Metro South West Development Assessment Panel Agenda

Meeting Date and Time: 8 April 2020; 1.30pm
Meeting Number: MSWJDAP/211
Meeting Venue: This meeting is available for members of the public to attend via electronic means.

8.1 Property Location: Lot 726 (No.591) Eighty Road, Baldivis
Lot 107 (No.577) Eighty Road, Baldivis
Development Description: Child Care Premises
Applicant: Planning Solutions
Owner: Mr George & Mrs Margaret Yiannakis
Mr Blair Thomas
Responsible Authority: City of Rockingham
DAP File No: DAP/19/01660

PYLON SIGN ELEVATION
1:100

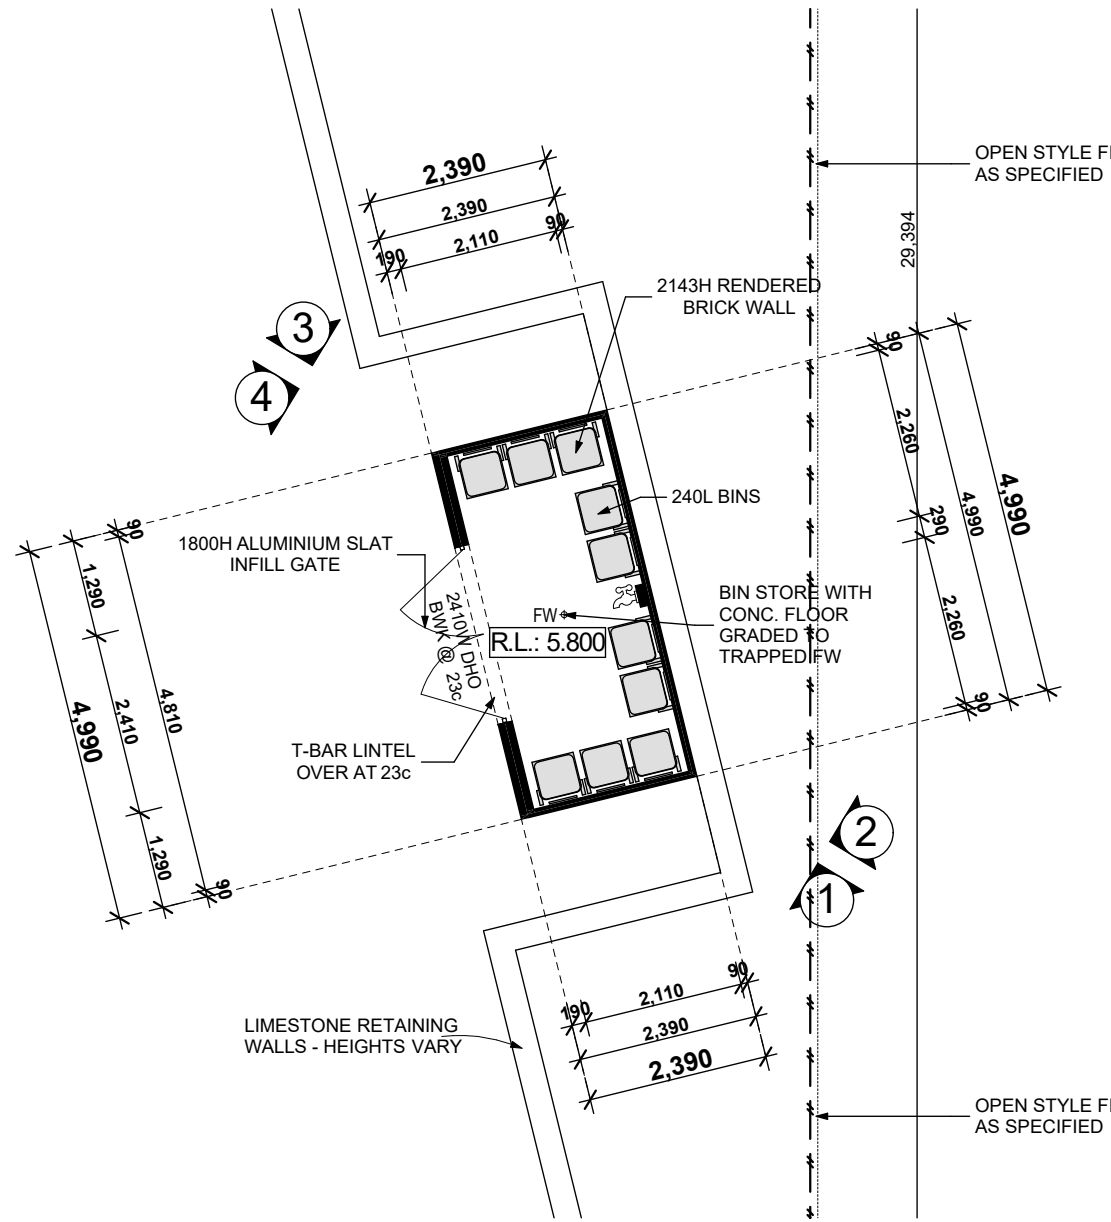
<p>setback from the common boundary.</p> <p>Non-Acceptable Variation</p> <p><u>Pylon Sign</u></p> <p>It is acknowledged that the proposed pylon sign is not akin to a typical pylon sign, and even without the removal of verge vegetation, the sign would still be highly visible to passing traffic as illustrated within the applicant's perspective (Figure 19 below). Although compliant with Planning Policy 3.3.1 - Controls of Advertisements, the sign is not considered to be sympathetic to the characteristics of the immediate area.</p> <p>A condition requiring the removal of the Pylon Sign is recommended should the application be approved.</p>
Clearing of Vegetation		
<p>No native or remnant vegetation shall be removed or cleared unless approved by the Local Government, and other than for the purpose of a fire break, fire protection within a asset protection zone, dwelling, outbuilding, fence and vehicular access or where such vegetation is dead, diseased or dangerous.</p>	<p>A total of 10 trees are required to be removed to facilitate the proposed development. All trees identified for removal are on-site. The proposed development was supported by an environmental assessment, which considered the conservation value of vegetation contained within the site.</p>	<p>Yes, as native trees within the verge are retained. While the retained vegetation may be degraded from a biodiversity perspective, it still plays a role in setting and maintaining the rural visual amenity of the locality. Pruning of the subject trees will not be approved by the City.</p>
